Subject: **Response to Portion of NRC Request for Additional Information
Letter No. 49 Related to ESBWR Design Certification Application –
Nuclear Design – RAI Number 21.6-54**

**Response to Portion of NRC Request for
Additional Information Letter No. 49 Related to
ESBWR Design Certification Application**

RAI Number 21.6-54

NRC RAI 21.6-54

Figure 1-1 from NEDC-33239P

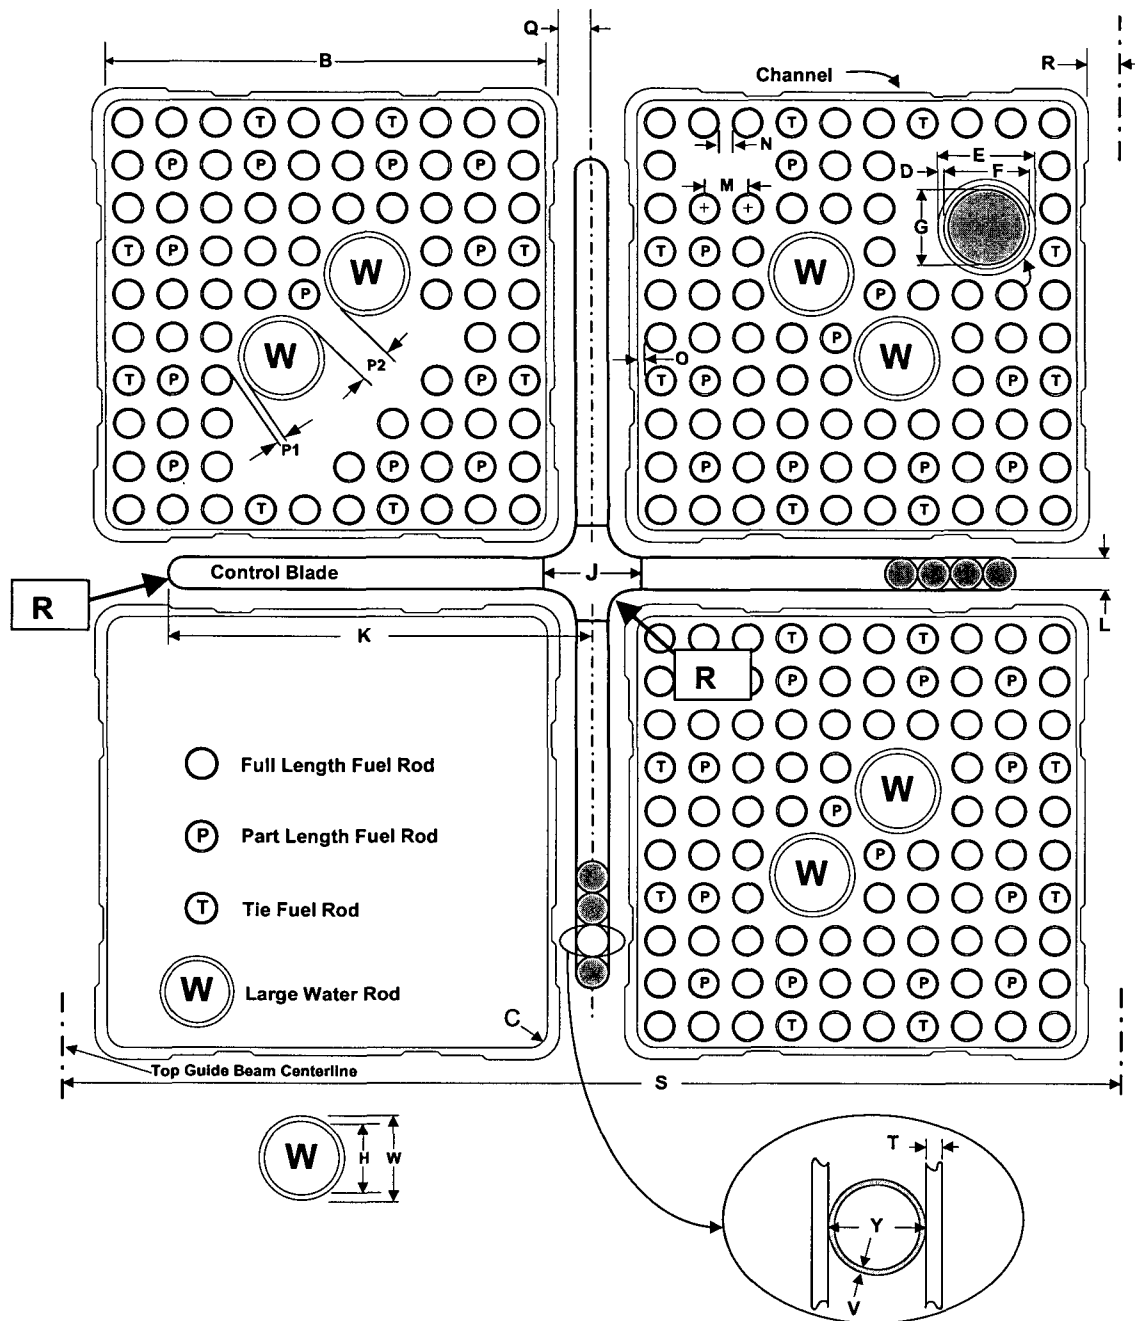
- E. Bundle structural materials and associated densities*
- F. Dimensions, compositions, densities and typical operating temperatures for the control rods*

- G. Dimensions for the letters in diagram in Figure 1-1 for bundles 90018 and 90019*
- H. Additional information defining exactly what is meant by the terms "shutdown margin" and "control rod worth"*

The following figure is Figure 1-1 from NEDC-33239P. The dimensions with respect to the nomenclature:

K = 12.45 cm, ½ span of control rod.

J = 3.937 cm, central support span (i.e. tie rod span).

L = 0.8331 cm, control rod wing thickness

T = 0.1143 cm, sheath thickness

Y = 0.5588 cm, absorber tube outer diameter

V = 0.06858 cm, absorber tube thickness

R1 = 0.0762 cm, central support span radius

R2 = 0.41656 cm, control rod wing tip radius

18 = number of B₄C absorber rods per wing

G. See the following table 21.6-54-1. Dimensional data for bundles 90019 and 90018 are taken from NEDC-33239P Figures 3-2, 3-3, 3-5, and 3-6.
